**Northern
Development
Assessment**

**RE: SSD-75493483 – INTEGRATED SENIORS LIVING DEVELOPMENT – OBJECTION TO STATE
SIGNIFICANT DEVELOPMENT APPLICATION.**

PPTY: 2–32 JUNCTION STREET, FOREST LODGE NSW 2037 (SUBJECT SITE)

Unit 208 (Lot 32), 1–3 Larkin Street, Camperdown

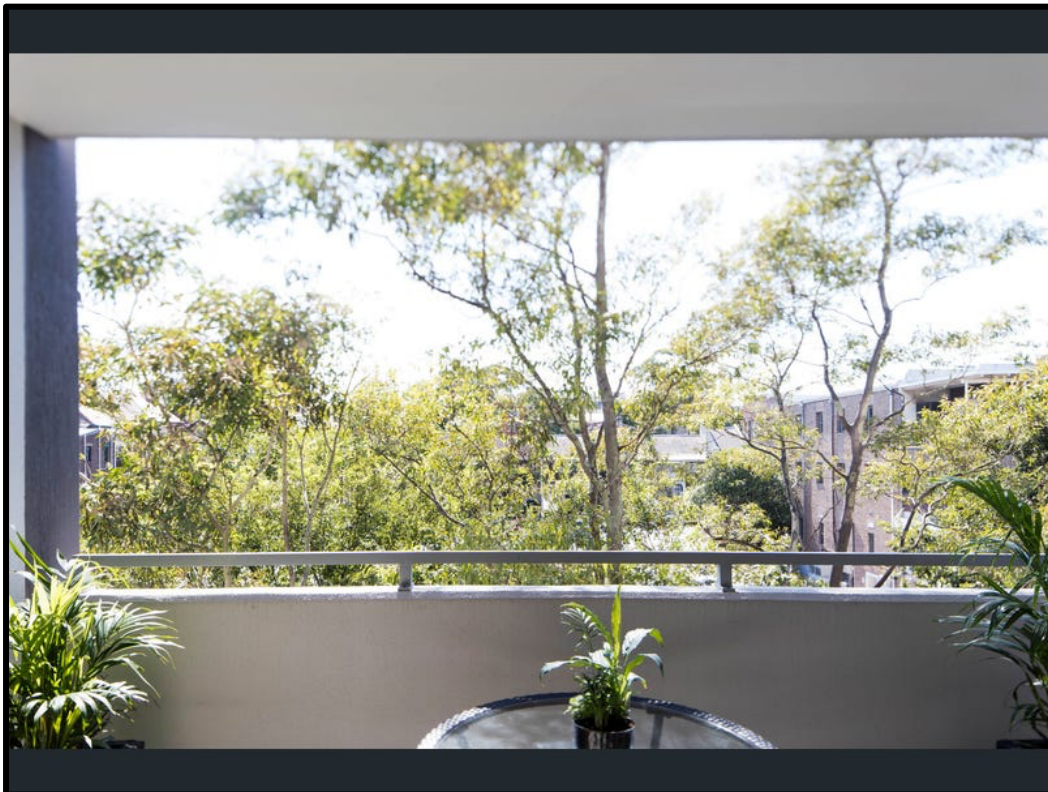
Photographs and accompanying documentation confirm that the Level 2 apartments at 1–3 Larkin Street are oriented east, facing directly toward the subject site at 2–32 Junction Street, Forest Lodge. The existing outlook consists of dense tree canopy, filtered sky, and glimpses of mid-distance development along Junction Street. These elements combine to provide an attractive vegetated outlook, a sense of openness, and valuable natural daylight for the second-level apartments. It is acknowledged that the maintenance of distant skyline views from this level would be difficult under any redevelopment scenario, given the relative height difference between the properties and the existing vegetation. However, the proposed design introduces a degree of bulk and height far greater than what would occur under a compliant scheme. The new five-storey Building A, including the wholly non-compliant Level 5 and enlarged Level 4, will extend well above the current roofline and canopy height, removing all filtered sky views and replacing the existing outlook with solid built form.

Although some reduction in outlook would be expected given the second-level position, the proposed scale and non-compliant massing significantly amplify the impact beyond what is reasonable. The addition of two full levels of non-compliant floor space, particularly the fifth storey and rooftop structures, fills the entire vertical and horizontal extent of the current outlook. For Units 208 and 211, the proposal removes all filtered sky and replaces it with a wall of building mass. Unit 213, which currently enjoys a heavily vegetated outlook, will lose the existing balance of greenery and sky once the boundary trees identified for removal are cleared and replaced by the visible façade of Building A. Unit 214, which presently benefits from strong daylight and a landscaped outlook, will experience a marked loss of openness as the building rises above the canopy line and occupies the entire skyline view corridor.

The impact across Level 2 is therefore assessed as severe, as the cumulative effect of the additional height, bulk and tree removal produces a complete loss of sky and daylight exposure to the east-facing apartments.

While it is accepted that some view loss from the second level would occur with any redevelopment, the current proposal represents an unreasonable and avoidable intensification of that impact. The design exceeds the permissible 1.25:1 FSR by 56 percent, introducing more than two storeys of non-compliant floor space and elevating the built form well beyond the expected scale for the locality. These breaches, rather than the redevelopment itself, are the direct cause of the total obstruction of outlook for the second-level apartments.

A compliant 1.25:1 scheme would achieve a lower and more articulated form, preserving at least partial tree canopy and filtered sky exposure and avoiding the overwhelming enclosure now proposed. The excessive massing of Building A therefore fails the reasonableness test in the *Tenacity*
